NORTH CAROLINA DEPARTMENT OF
ENVIRONMENT AND NATURAL RESOURCES

February 15, 1999

Subject: SWMU Assessment Report (SAR)
MACS 6 Battery Service Room Leach Field
MCAS-Cherry Point, NC

MACS-6. BATTERY SERVICE ROOM LEACH FIELD
 SAMPLE LOCATION MAP
 MCAS, CHERRY POINT, NORTH CAROLINA

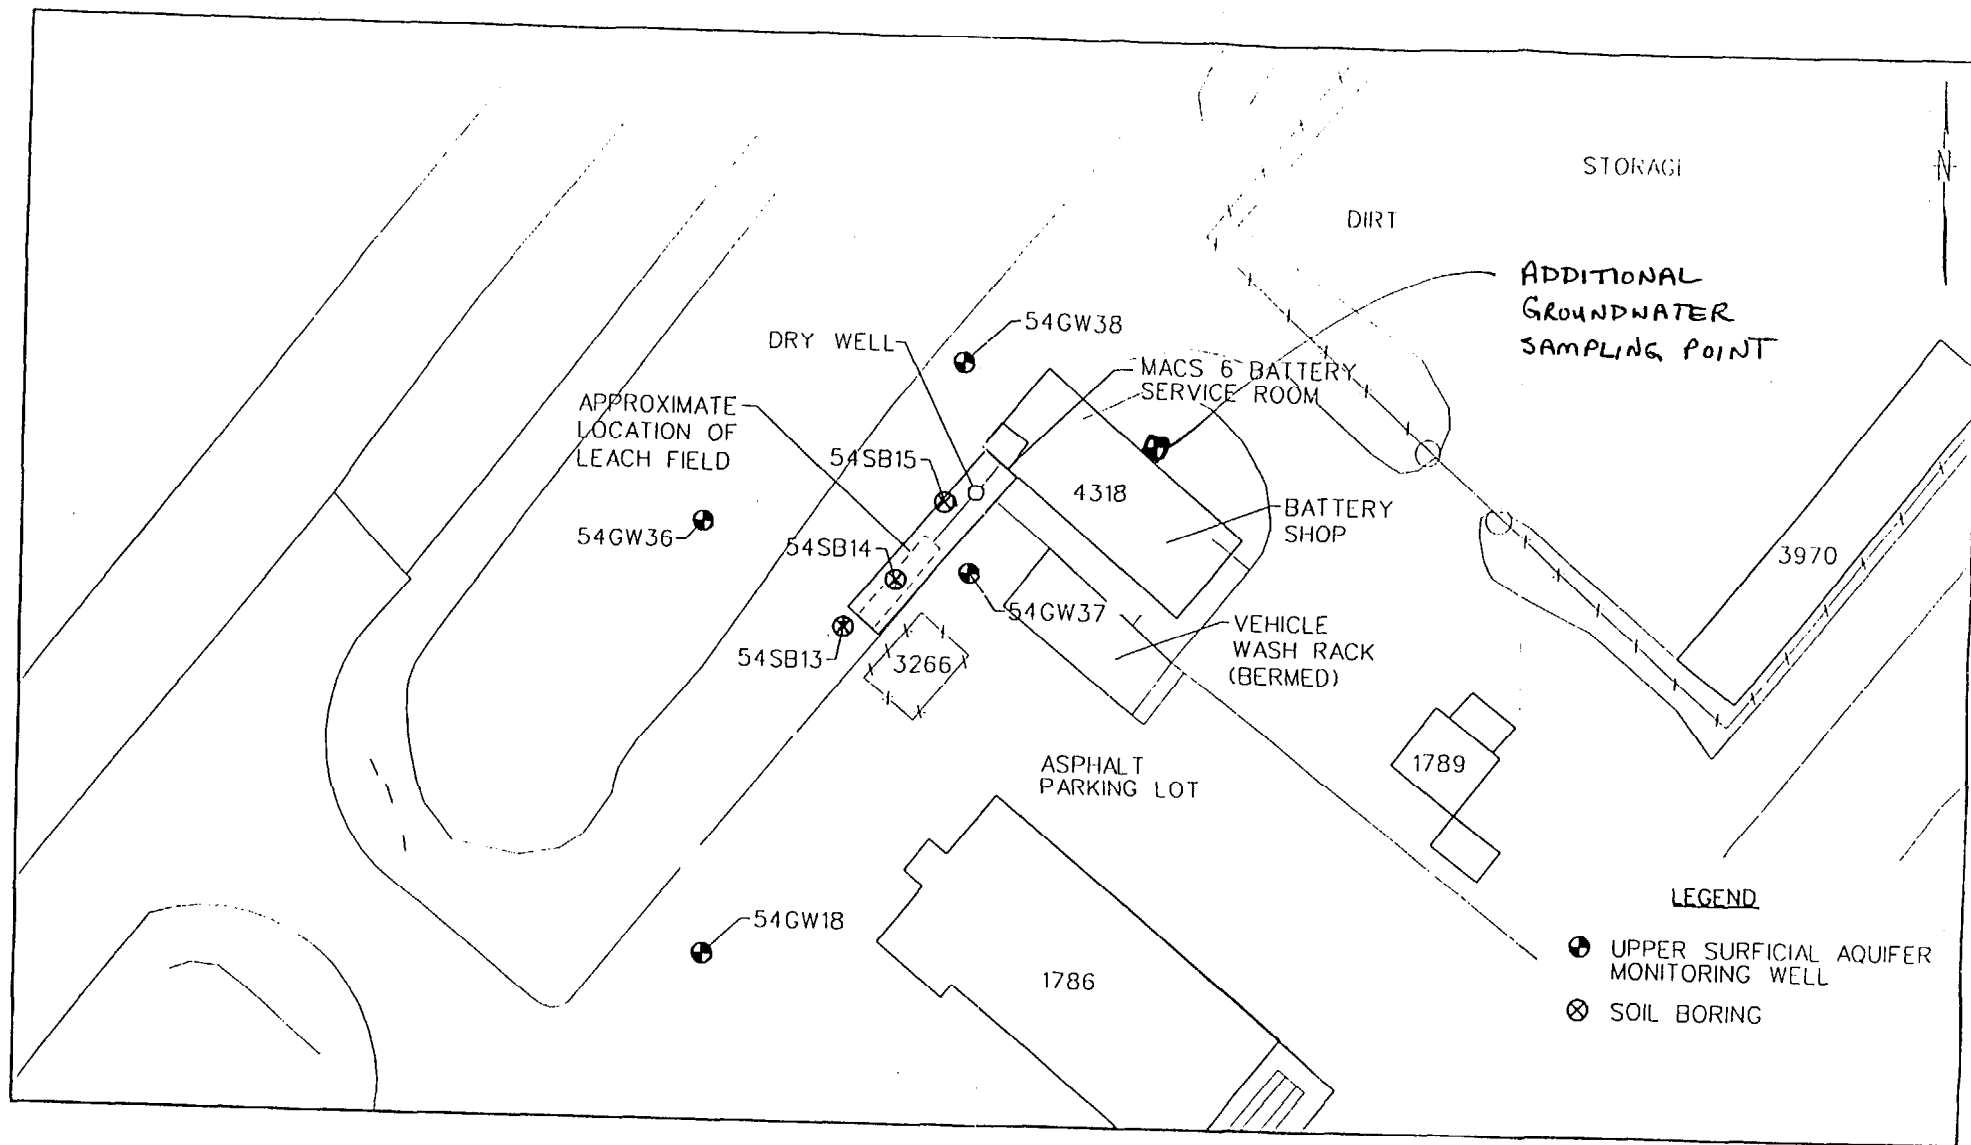
The North Carolina Superfund Section has reviewed the subject document. Because the groundwater flow direction in the vicinity of this site may be somewhat in the eastern direction, an additional groundwater sampling point is necessary to evaluate the potential release from the drainfield, septic tank and associated lines to the MACS 6 battery service room. Attached is a map indicating the approximate location of an additional sampling point. (Note: Several maps reviewed for this area label this building either 4318 or 3265. Which is correct?) Analyses for this additional groundwater sample should be the same as that of the previous three samples collected (TCL volatile and semivolatile organic compounds, pesticides, PCBs, TAL metals plus cyanide).
